# Memorandum

SUBJECT: North Byron FRMS&P – Initial and Continuing Loss Sensitivity Test

PROJECT NUMBER: 117098

Figure 1: Initial Loss Sensitivity Analysis results, 1% AEP event

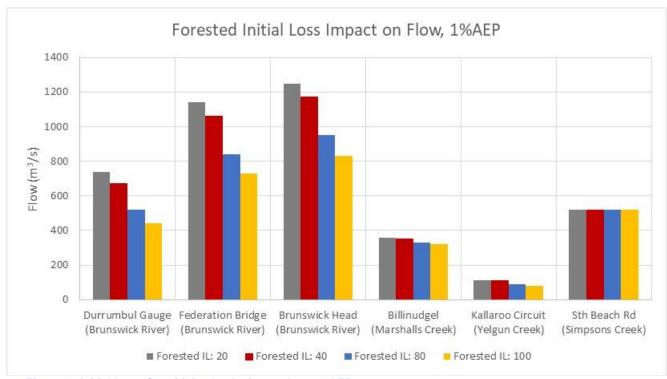
Table 2 and Figure 1 show the modelled flow at various locations in the catchment, for the four IL scenarios, for the 1% AEP design event.

Adjustment to the 'forested' IL value has a significant impact on Brunswick River flow. At Durrumbul, flow varies from 440m³/s to 740m³/s depending on IL. It corresponds to a flow increase of 41% for an IL value decrease from 100mm to 20mm. A similar difference is calculated at Federation Bridge in Mullumbimby (730m³/s to 1140m³/s, 36%) and on Brunswick Mouth (830m³/s to 1250 m³/s, +34%).

The impact is less for Marshalls Creek (±40m³/s, 9% difference at Billinudgel) and for Yelgun Creek (±30m³/s, 27% difference at Kallaroo Circuit). There is no impact on Simpsons Creek flow as the catchment is almost exclusively classed as Rural.

Forested IL values have a notable impact on Brunswick River modelled flow that leads to a reduction of  $420 \, \text{m}^3$ /s for the 1% AEP design event.

Figure 2: Initial Loss Sensitivity Analysis results, 20% AEP event

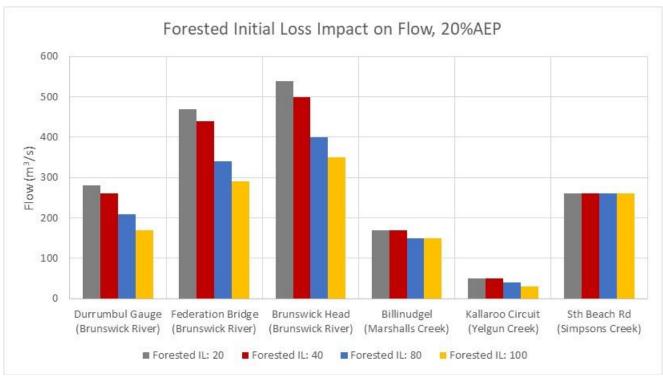
For the 20% AEP design event, the impact on flow is still substantial in the Brunswick River. Flow varies from  $170 \text{m}^3$ /s to  $280 \text{m}^3$ /s (+39%) at Durrumbul Gauge.

Similar to the 1% AEP event, flow is less sensitive to IL changes for Marshalls Creek and Yelgun Creek and is non-existent for Simpsons Creek.

Figure 3: Initial Loss Sensitivity Analysis results, PMF event

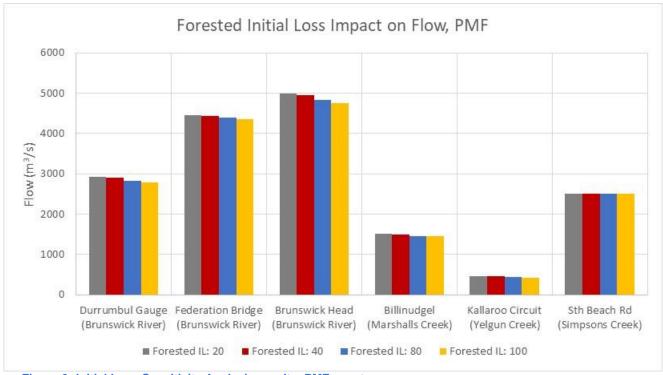
For the PMF event, sensitivity tests show that whilst an IL value change can cause an increase of 250m³/s on the downstream part of Brunswick River (Brunswick Head), this only represents 5% of the total flow. Thus, changes in IL values results in a less significant flow change (varying between 4750m³/s and 5000m³/s). There is almost no impact on Marshalls Creek and Yelgun Creek.

Figure 4: Continuing Loss Sensitivity Analysis results, 1% AEP event

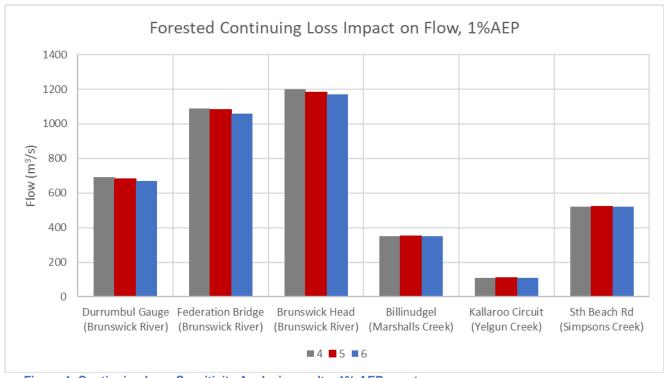
Table 5 and Figure 4 show the modelled flow at various locations in the catchment, for the three CL scenarios, for the 1% AEP design event.

Adjustment to the Forested CL value has minimal impact on Brunswick River flow. At Durrumbul, flow varies from 670m<sup>3</sup>/s to 690m<sup>3</sup>/s depending on CL. It corresponds to a flow increase of only 3% between 6mm/hr and 4mm/hr. A similar difference is calculated at Federation Bridge in Mullumbimby (1060m<sup>3</sup>/s to 1090m<sup>3</sup>/s, 3%) and on Brunswick Mouth (1170m<sup>3</sup>/s to 1200m<sup>3</sup>/s, 3%).

There is no impact for Marshalls Creek, Yelgun Creek and Simpsons Creek.

Figure 5: Continuing Loss Sensitivity Analysis results, 20% AEP event

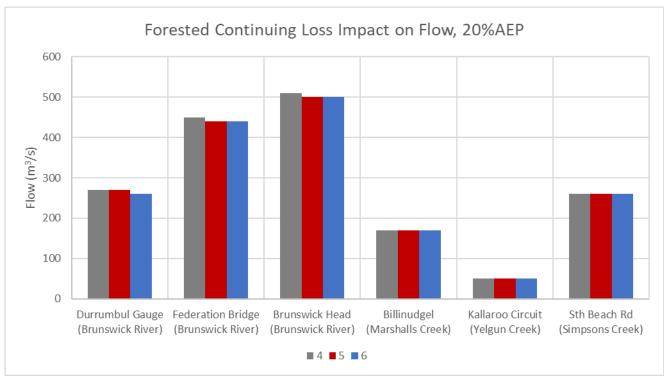
For the 20% AEP design event, there is almost no impact on flow. The most important impact occurs at Durrumbul Gauge (260m³/s to 270m³/s, 4%).

Figure 6: Continuing Loss Sensitivity Analysis results, PMF event

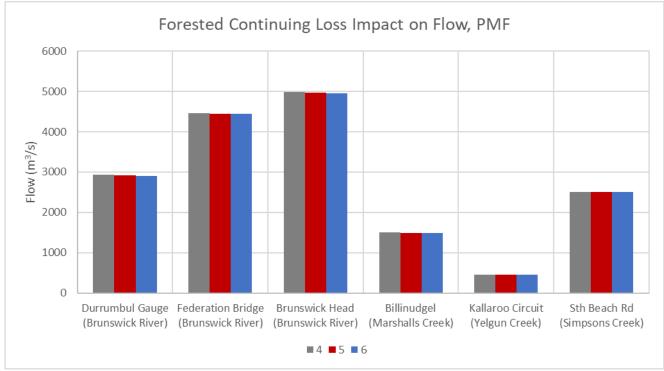
For the PMF, sensitivity tests show that a CL value change can cause an increase of only 20m³/s on Brunswick River. It represents less than 1% of the total flow.
